Customer Legal Recall

MAS004306
(CLR 24-07)

Customer Legal Recall # 730 – U.S. MY22, MY23, MY24 – MC20 and MC20 Cielo Weight Indication and Tire Label Replacement

Manufacturer Placard replacement (Coupé + Cielo)

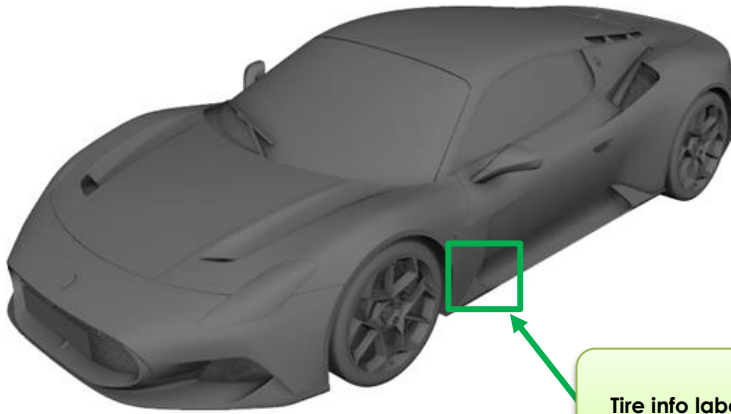
1. Identify the labels to update inside the left side door, underneath.

2. Use isopropyl alcohol and a clean microfiber cloth to carefully clean the area of any debris.
3. Carefully position and apply the new label on top of the existing one. Use a soft Telfon tool to remove any air bubbles.

Align and apply the new label in the green area, exactly on top of the old values.

Tire info label

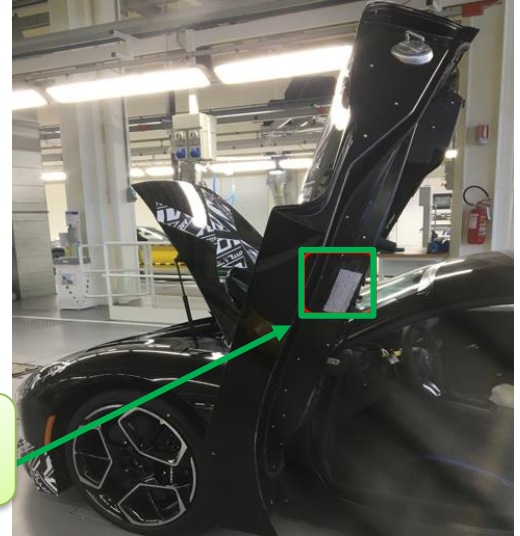
- Proceed with replacing the "Tire Pressure Information" label, which is always positioned under the left door frame.
- Use a heat gun to remove the old label.

- After removing the old label. Use isopropyl alcohol and a clean microfiber cloth to carefully clean the area of any leftover residue.

Incorrect vehicle weight capacity

TIRE AND LOADING INFORMATION			
SEATING CAPACITY - TOTAL 2 FRONT 2 REAR 0			
THE COMBINED WEIGHT OF OCCUPANTS AND CARGO SHOULD NEVER EXCEED 180 kg OR 397 lbs.			
TIRE	FRONT	REAR	SPARE
ORIGINAL TIRE SIZE	245/35 ZR20 (95Y)	305/30 ZR20 (103Y)	NONE
COLD TIRE INFLATION PRESSURE	220 kPa / 32 psi	220 kPa / 32 psi	NONE

180 kg OR 397 lbs.

Correct vehicle weight capacity

TIRE AND LOADING INFORMATION			
SEATING CAPACITY - TOTAL 2 FRONT 2 REAR 0			
THE COMBINED WEIGHT OF OCCUPANTS AND CARGO SHOULD NEVER EXCEED 136 kg OR 300 lbs.			
TIRE	FRONT	REAR	SPARE
ORIGINAL TIRE SIZE	245/35 ZR20 (95Y)	305/30 ZR20 (103Y)	NONE
COLD TIRE INFLATION PRESSURE	220 kPa / 32 psi	220 kPa / 32 psi	NONE

136 kg OR 300 lbs.

- Carefully position and apply the new label in place of the old one. Use a soft Telfon tool to remove any air bubbles.
